Review 1  
Preliminary and Final Major Site Plan  
w/Variances  
101 Bayonne, LLC

Block 359, Lot 4.03  
101 East 2nd Street  
Heavy Industrial (I-H) District

March 7, 2023

Proposed canopy sign above and proposed wall sign to the right.

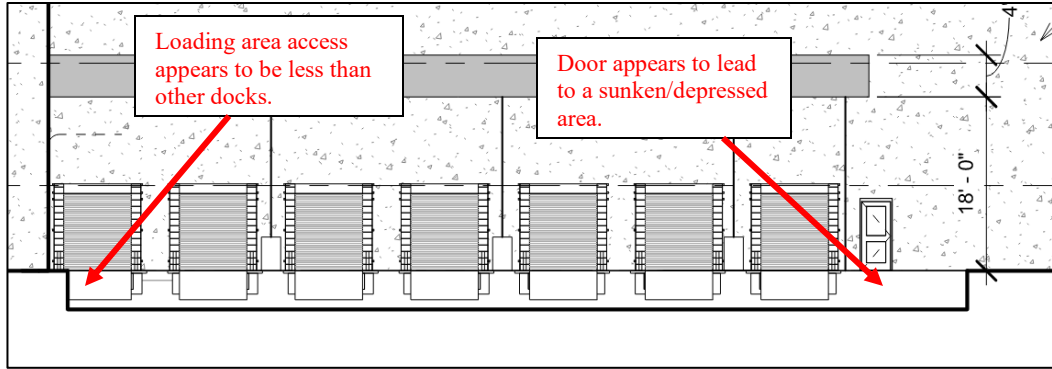
- 3.3.1. Maximum Permitted Signage. Pursuant to §35-25.4.c, signs shall not exceed 20% of the sign façade area as defined in the ordinance. The ordinance defines this as the floor-to-floor height of the occupied space, or in this case, floor-to-roof height as the building contains one floor. Also, it is unclear whether the warehouse will be serving one business or two - as this would determine what percentage of the frontage can be used for each business' sign. There is enough frontage available such that the proposed signs conform whether there is one or two businesses occupying the space.

- 3.3.2. Wall and Canopy Signs. Pursuant to §35-25.4.c.1, walls signs (canopy signs are regulated as wall signs) are permitted providing that they do not exceed three square feet for each linear foot of sign frontage. Sign frontage refers to the portion of the building frontage facing a street right-of-way or private drive. The 709 linear feet of frontage meets this standard, allowing for 2,127 sf. of permitted sign area. The applicant is proposing 587± sf. of total wall/canopy sign area, which conforms. Additionally, the proposed canopy signs do not extend beyond the edges of the canopy, which conforms.
